Re: Draft Title V Permit [incorporating the Re-powering Action for Unit 5] 1270009-007-AV/1270009-008-AC/PSD-FI-270(A)

DRAFT COMMENTS for DISCUSSION PURPOSES SANFORD POWER PLANT 9/08/03

Re: Response to Department Request dated Oct. 10, 2002: Title V Permit Revision Request to incorporate the Repowering Action for Unit 5 1270009-007-AV/1270009-008-AC/PSD-FI-270(A)

RE: FPL SANFORD PLANT
Title V Revision to Include Repowered Unit 5
DEP File No. 0270009-001-AC (PSD-FL-328)

Figure 6-2: HP Drum Temperature and Pressure During Cold Startup

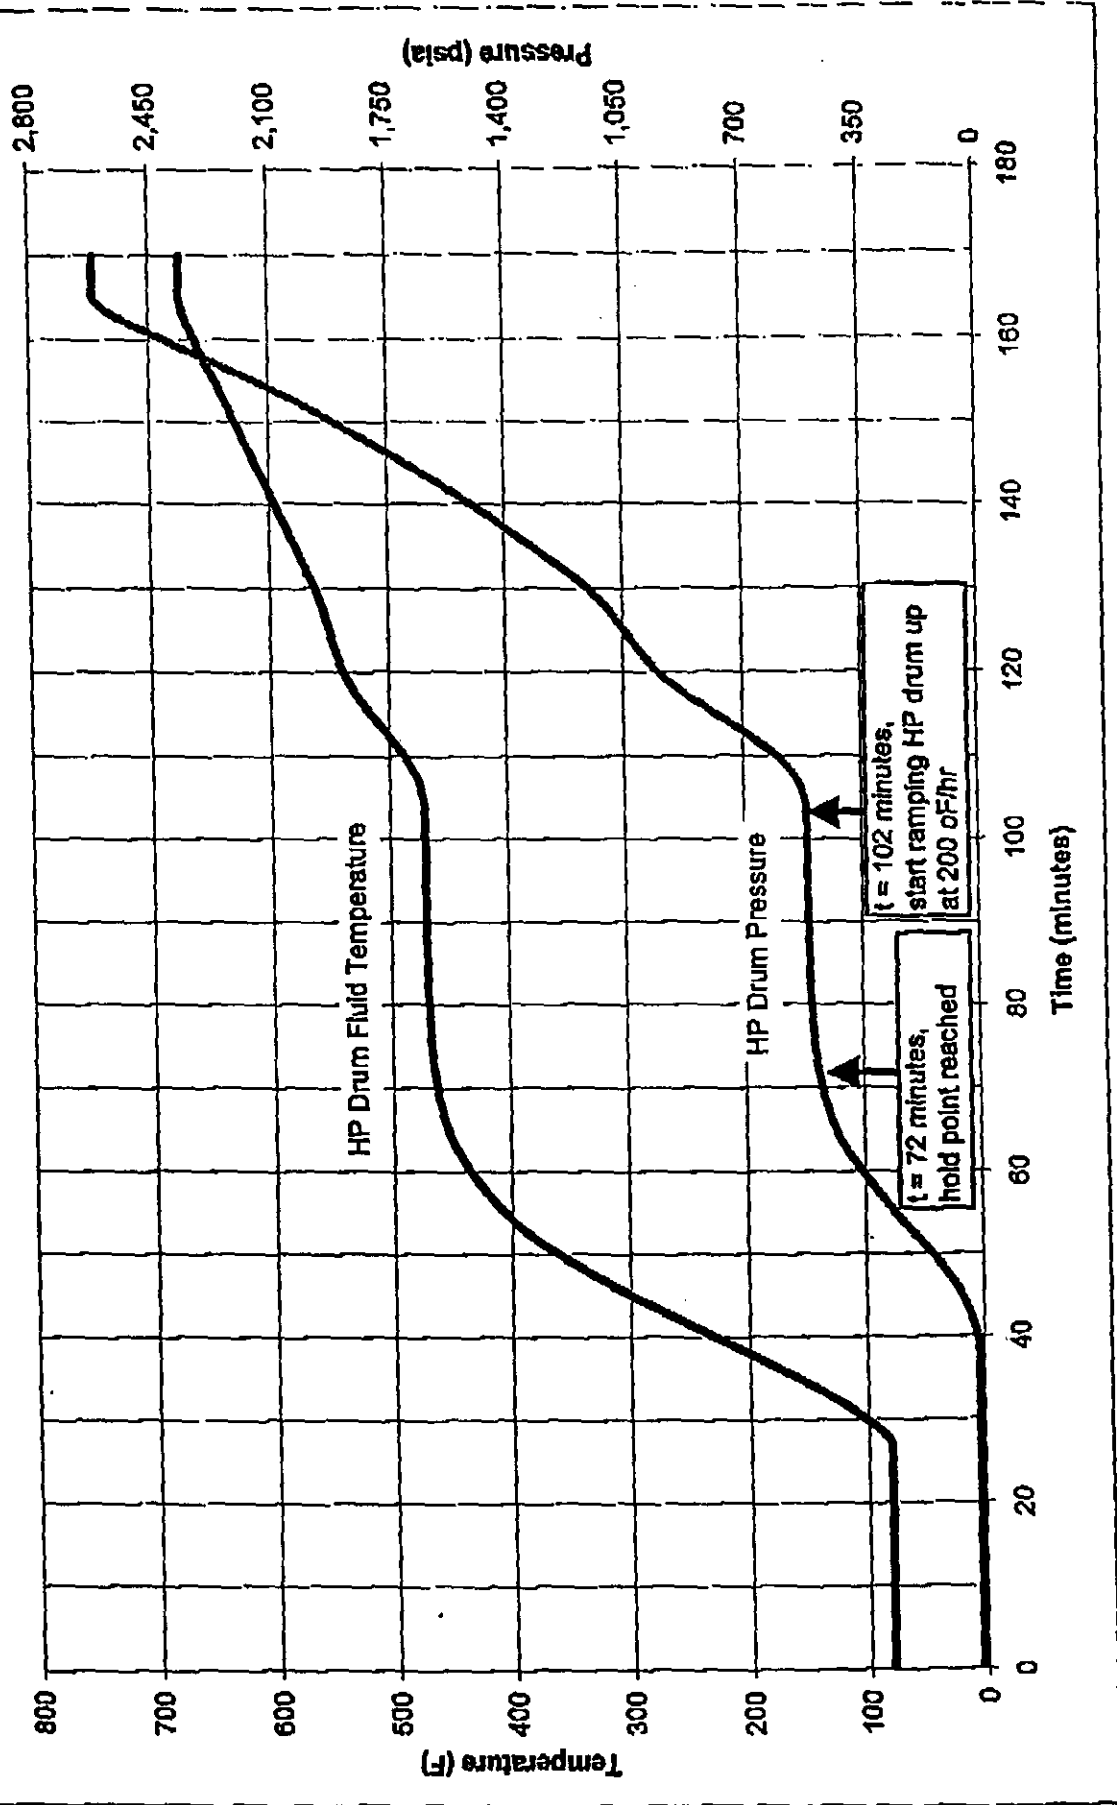
The second item concerns the supporting information regarding the proposed excess emissions language for the cold startup of the CT/HRSG systems. The Foster Wheeler requirement for cold start is found as paragraph, 6.3.3 Cold Start. In addition, the heat soak requirement specified by Foster Wheeler is found in paragraph 6.3.3.7. The HP Drum Temperature and Pressure During Cold Startup is shown as Figure 6-2. This information is attached [Attachment 2]

- 6.3.3.7 It is imperative that the HP drum pressure be held at 450 PSI for a minimum of 30 minutes in a "soak period" to allow for the equalization of thermal stresses on the unit, as shown in Figure 6-2.
